STAFF REPORT

CUP for a Supper Club &

Banquet Facility at 11770 Dellwood

White Pines Supper Club: Engineering Plan Review

SITE PLAN

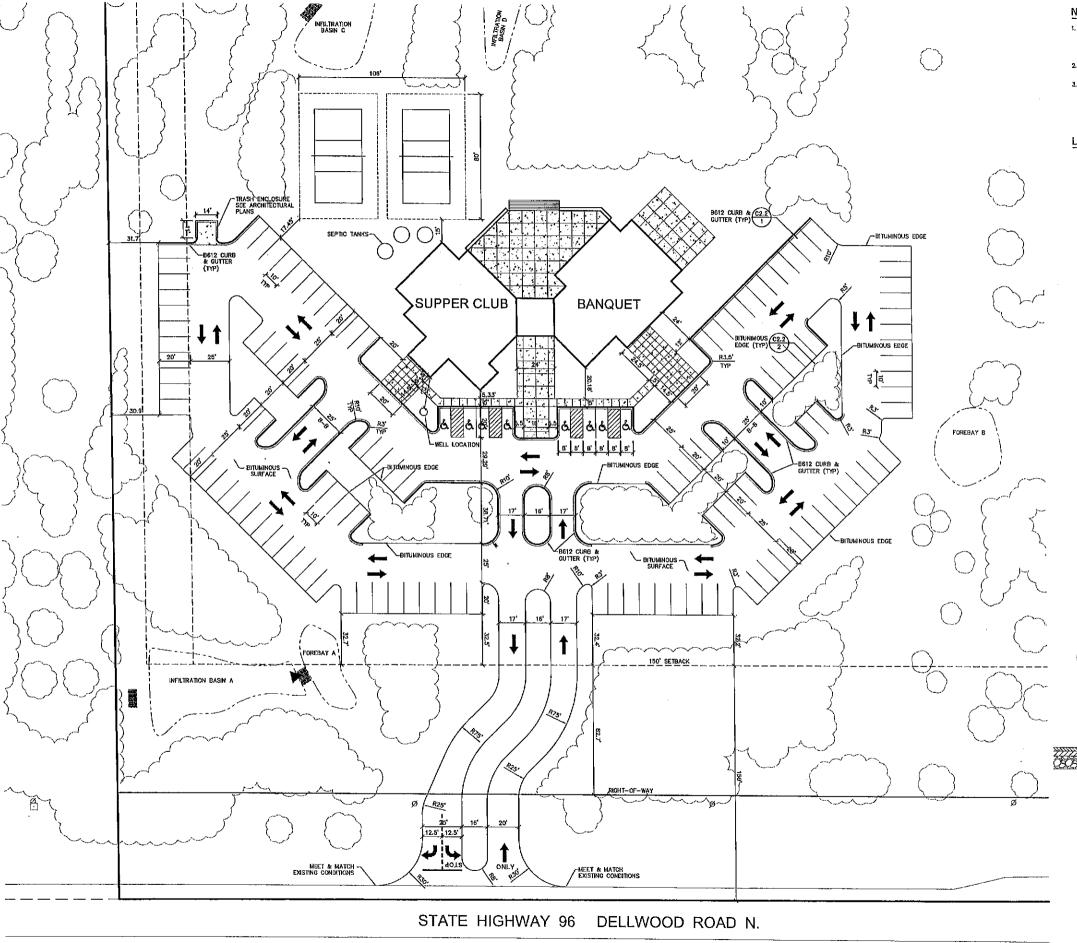
Sections 32-372 through 32-377 provide standards for design and development of off-street parking areas. In calculating the number of stalls, Section 32-374 identifies the number of required parking stalls based upon the proposed facility use. The Ordinance does not identify a specific conversion for banquet facilities, and therefore the calculation was performed based upon the Supper Club. As described in Sheet A1.2 and A1.4, the banquet facility is expected to accommodate approximately 128 guests, while the supper club has seating for 250. Based upon these occupancy numbers, the total number of guests would be 378, and the code requires 1 parking space be provided for every 2 ½ seats. This calculation results in required parking of 151 parking spaces. The following table summarizes the parking as shown on the proposed site plan (Sheet C2.1).

The analysis also does not accommodate or consider what parking needs might be needed if the recreational facilities were to be fully developed. At this time, it seems that the parking area should at a minimum be revised to accommodate a full max-out scenario to ensure available parking if some recreational events were to occur while the supper club and banquet facilities were operational. Based upon the submitted site plan, the parking area does NOT meet the current ordinance standards. The parking lot should be revised to accommodate an additional 15 parking spaces, so a total of 151 parking spaces are available.

OVERALL GRADING & **EROSION CONTROL PLAN**

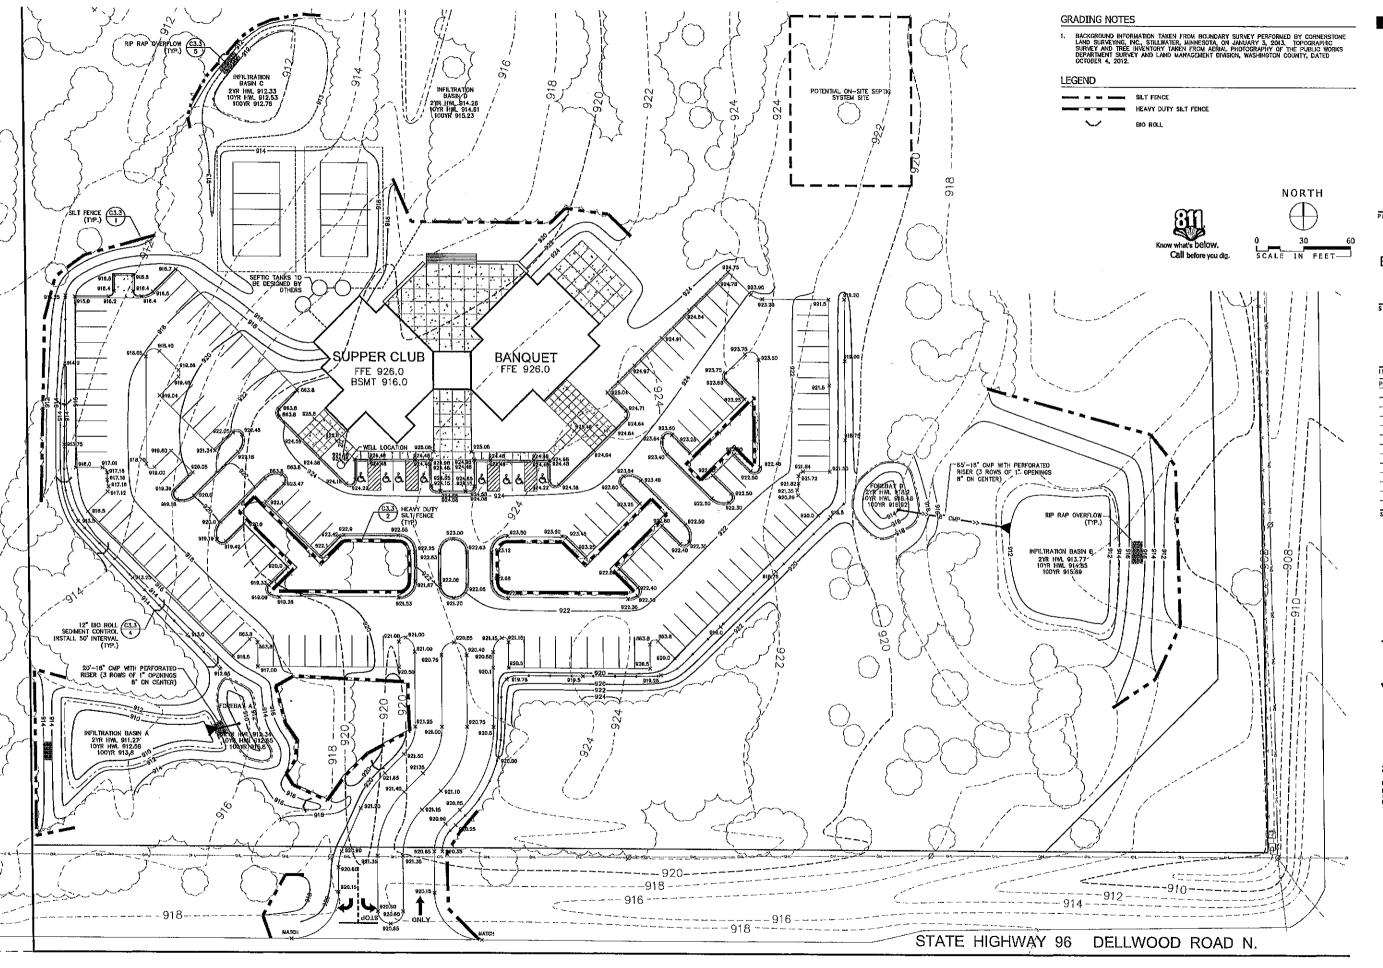
- 4. The future pathway and ballfield area are shown to be located within Infiltration Basin D. It is recommended to either relocate one of the improvements or show Infiltration Basin D as a temporary improvement that will be relocated with the construction of the future improvements. If relocated, the future ponding areas should be shown on the plan.

- 7. NGVD, 1929 Vertical datum should be denoted on the grading plans per Brown's Creek Waterhsed Management Rule 2.6.6.

8. Overland emergency overflow routes, directional flow arrows, and normal pipe outlet elevations are required to be shown on the plan.

10. A skimmer structure is called out in the stormwater plan but not on the plan sheet. The structure is required to be added to the plan. A detail should be added to show how the forebay outlet control structure stand pipe is to be constructed.
